**PLANNING COMMISSION MEETING**

**WEDNESDAY, JANUARY 28, 2026 at 7:00 PM**

Re: *New Business*  
*- B. Special Land Use & Site Plan Review — Detroit County Day School*

<b>Attention:</b>	Susie Stec, Planning and Zoning Administrator
<b>Subject:</b>	Detroit Country Day – Special Land Use and Site Plan Review #1
<b>Location:</b>	22305 West 13 Mile Road – southwest corner of the 13 Mile and Lahser intersection
<b>Zoning:</b>	R-1 Single Family Residential District

Proposed signage:

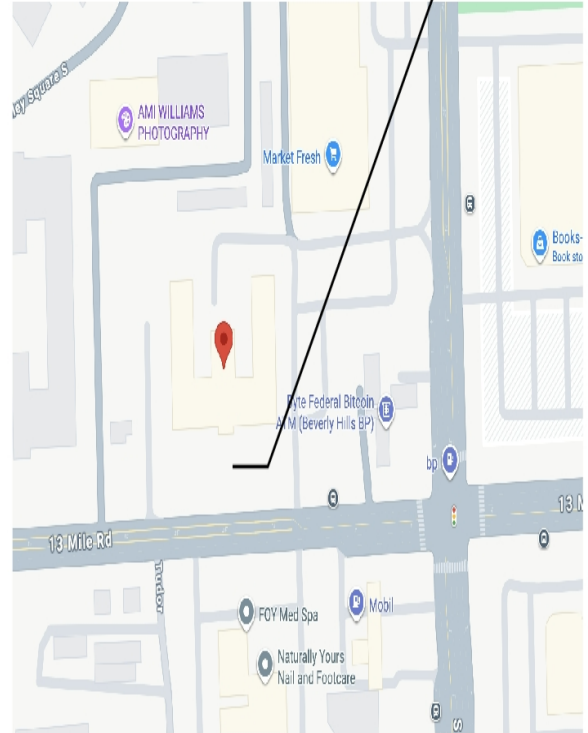
With that being said, we request the applicant correct the application form with respect to the size of the sign (32 SF noted), removal of the information for a 2<sup>nd</sup> sign (which is not proposed) and secondary street frontage (which the site does not have), and inclusion of the sign height and setback (the dimensions noted were taken from the Mission Point sign application review in 2021).

**25'2" x 18.34'**  
**DIGITAL DISPLAY**

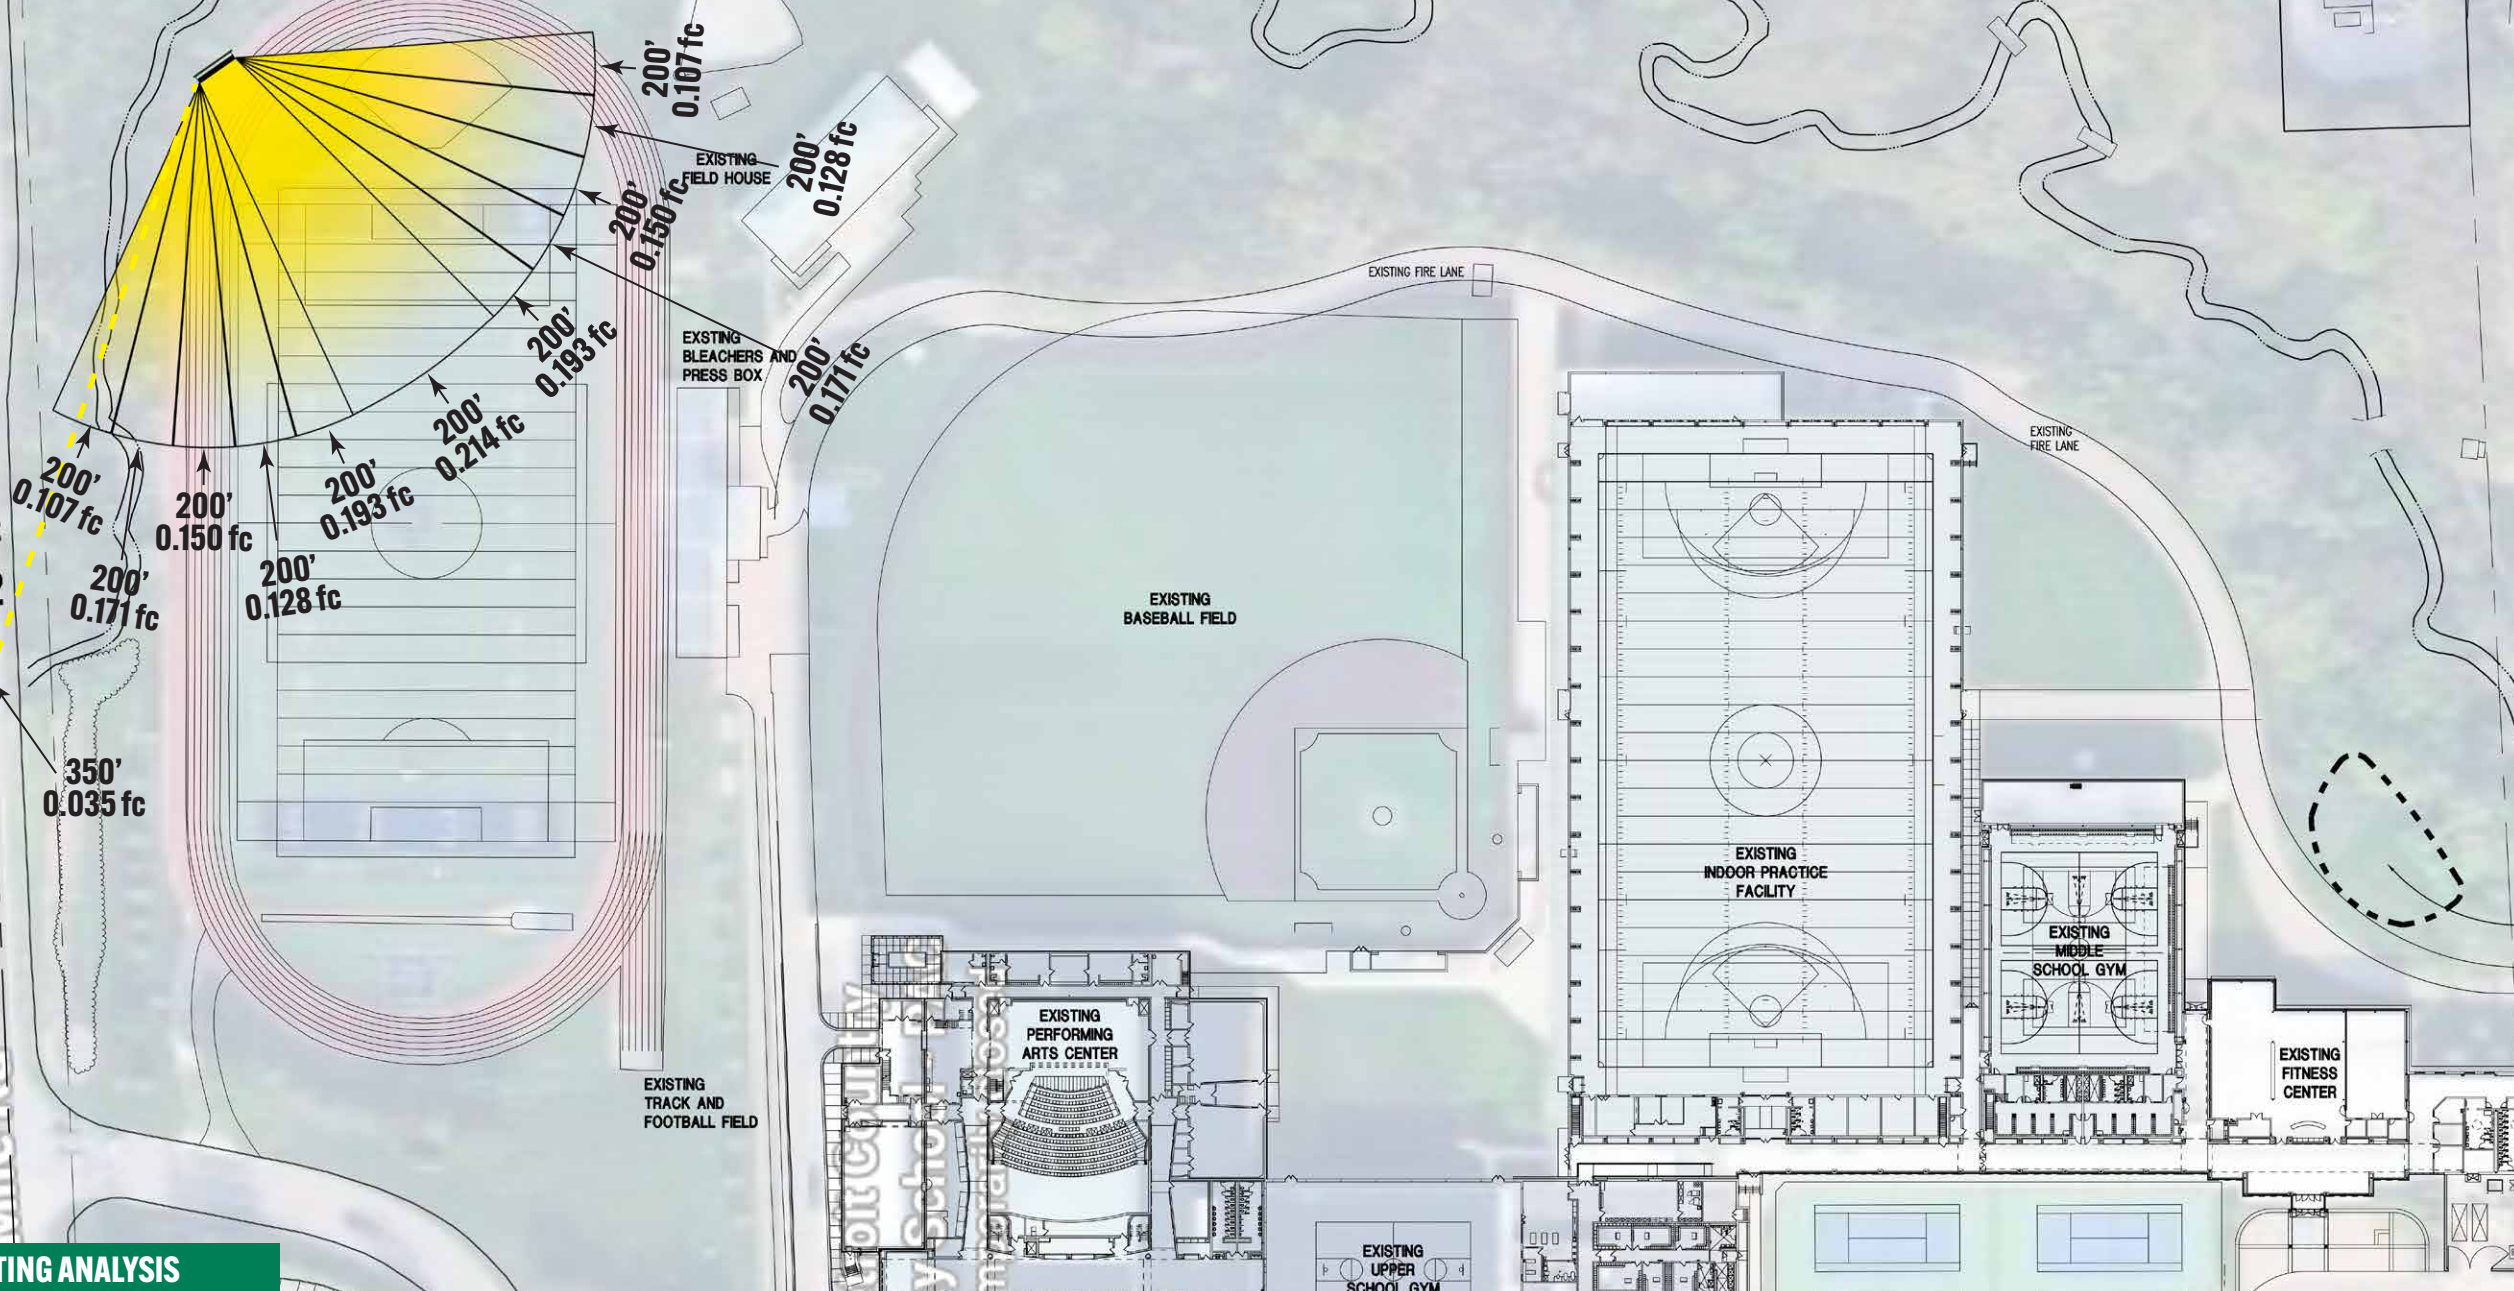
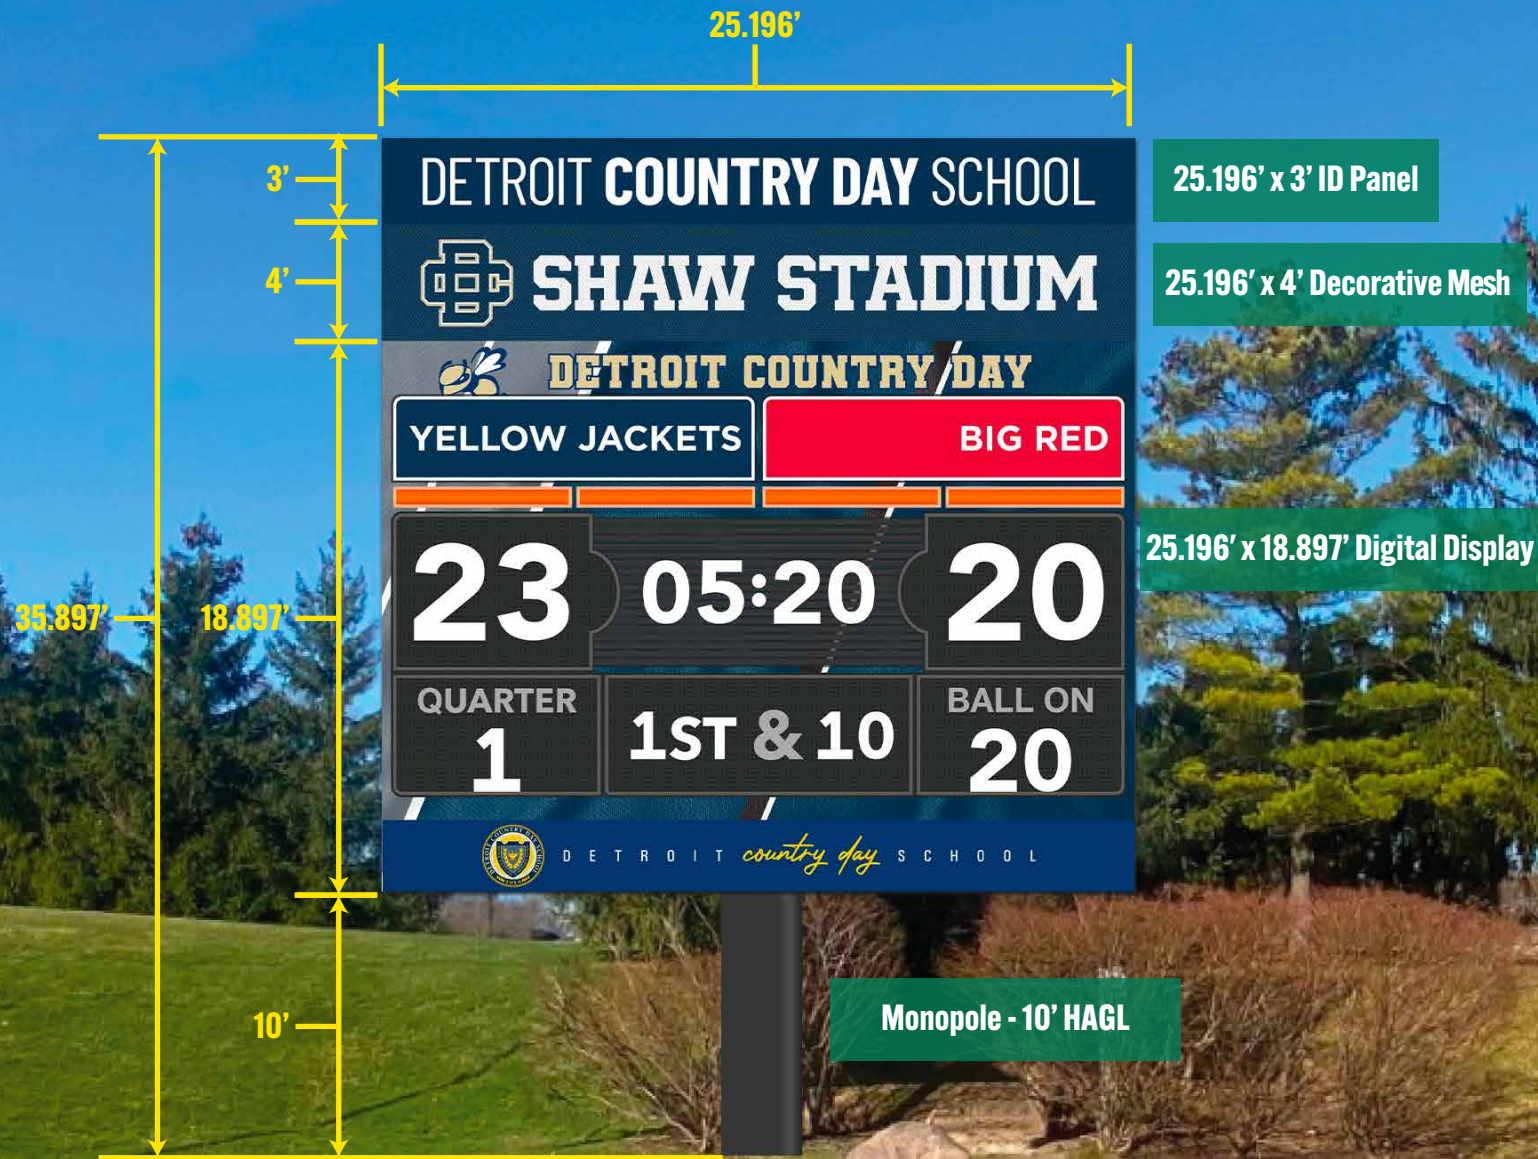
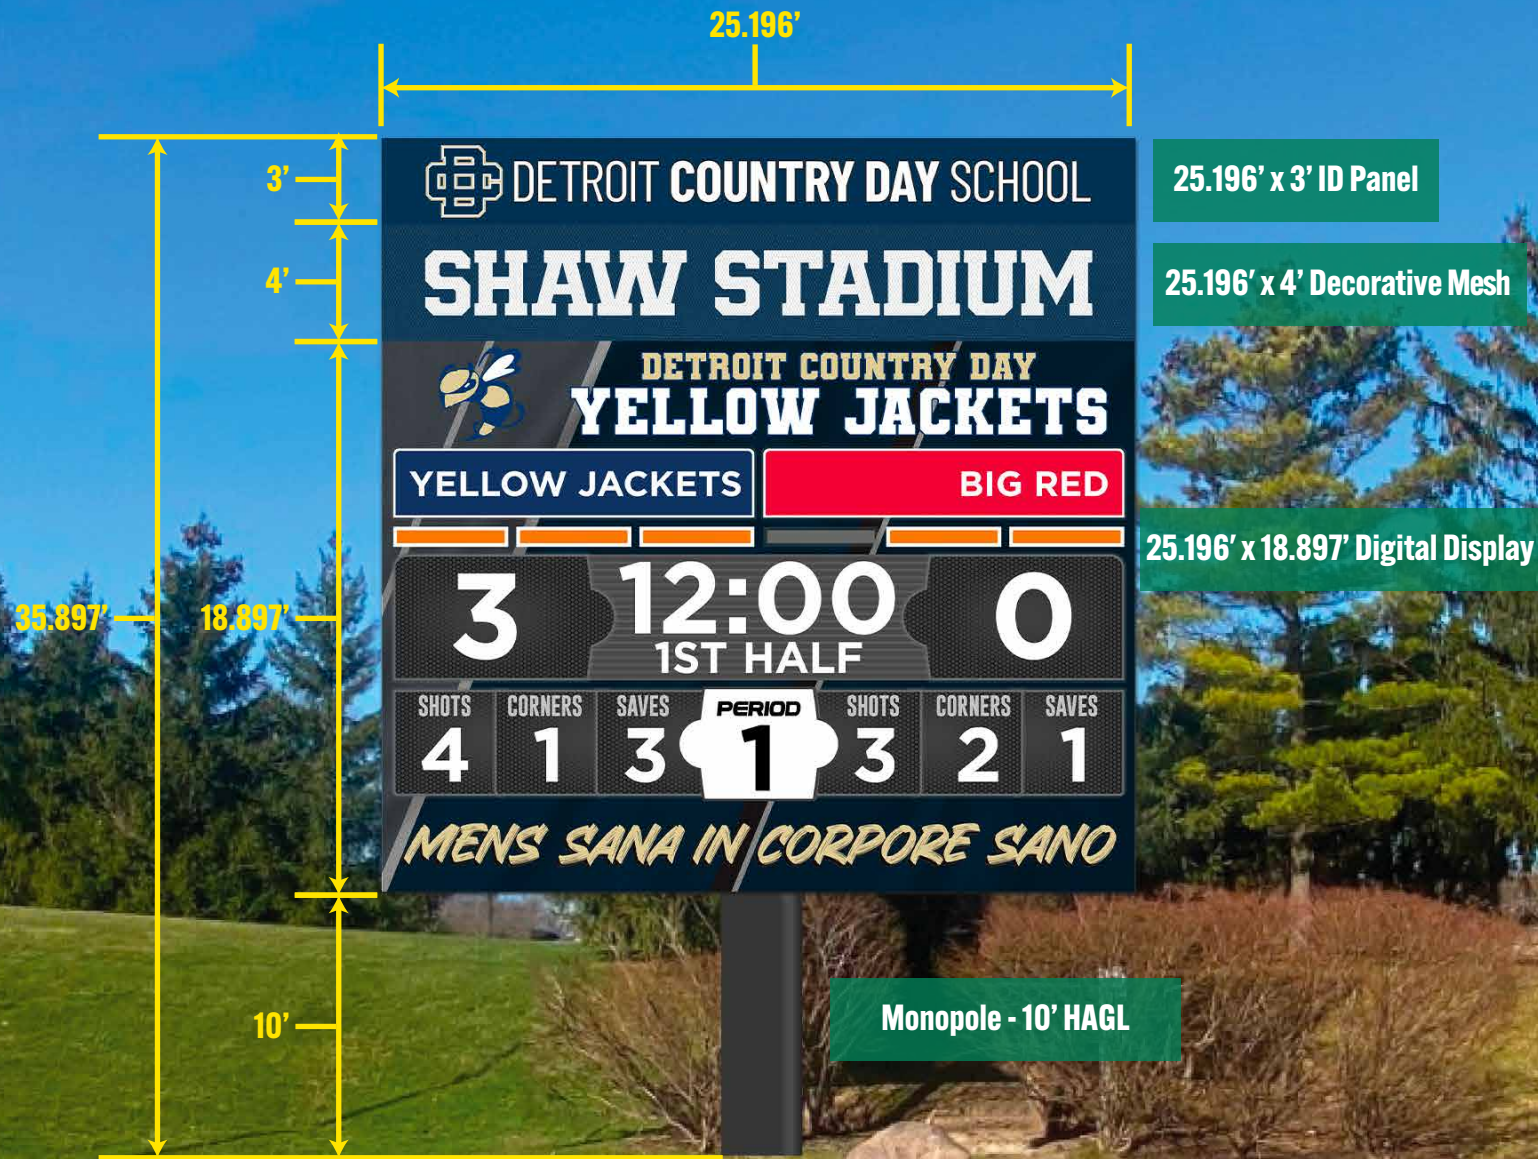
Additionally, more detail is needed for the light and noise that will be generated by the proposed scoreboard. Similar to comments above, the goal should be to maintain or improve existing conditions and not make them more impactful to surrounding properties/uses. The applicant may also provide further details as to how they will mitigate potential off-site impacts.

- This should be shown on the site plan [The scoreboard location is reflected on Sheet LA1.01](#)
- What are the physical dimensions of the scoreboard? Total height from grade.
- Sound system – what are the decibels?
- Light intensity – more details are required.
- No advertising is permitted. This was discussed.
